PSE: Dual-signature SM Class Probe, Class Reset

Problem Statement

Solution

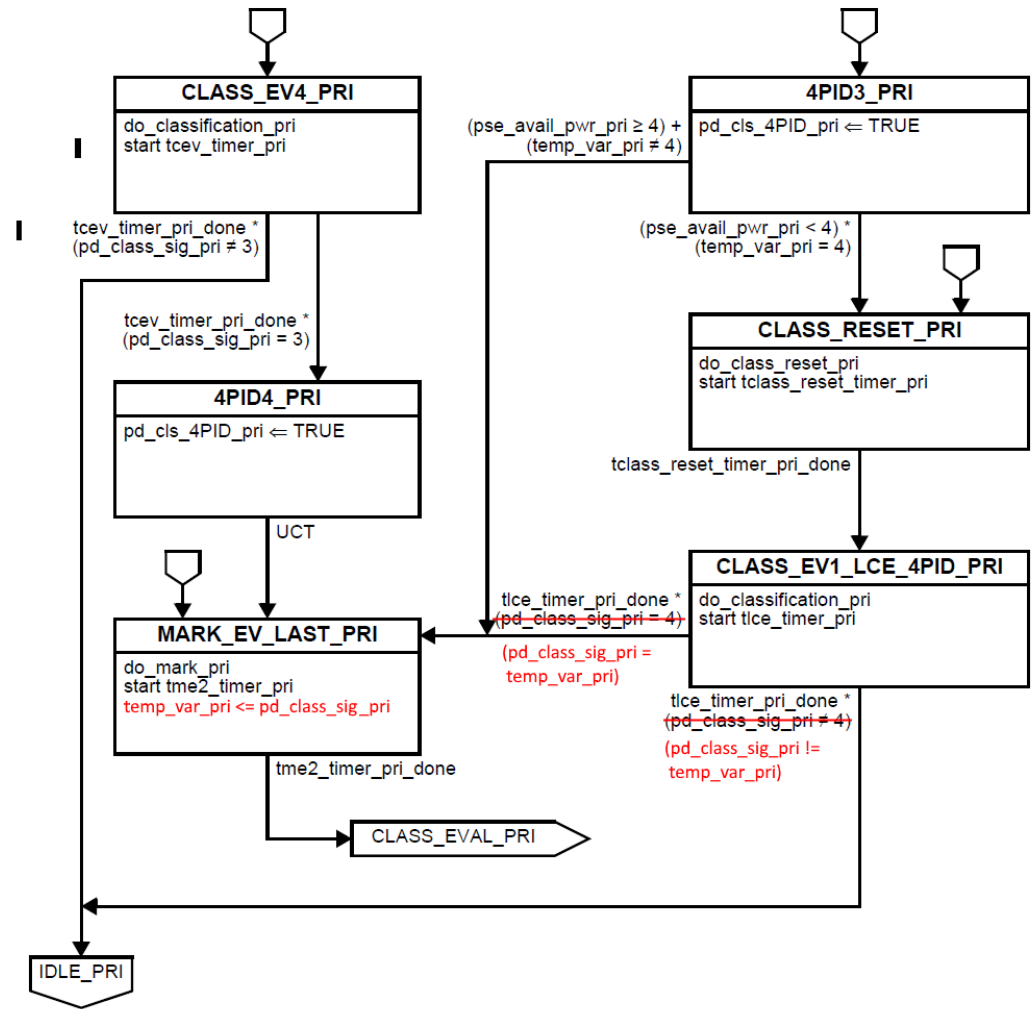
- ▶ In SISM, Class Reset double-checks `pd_class_sig`
 - Ensures PD class signature has not changed since `CLASS_EV1`
- ▶ In Draft 3.0, Class Reset only performed if `pd_class_sig = 4` in `CLASS_EV1`
- ▶ In Draft 3.1, Class Probe uses Class Reset function
- ▶ With Class Probe, Class Reset may be performed for `pd_class_sig = 1` to `4`

- Modify Figure 145–15 as shown
- Repeat for Figure 145–16
 - “SEC” state diagram
- Note: temp_var_X holds pd_class_sig from CLASS_EV1_X
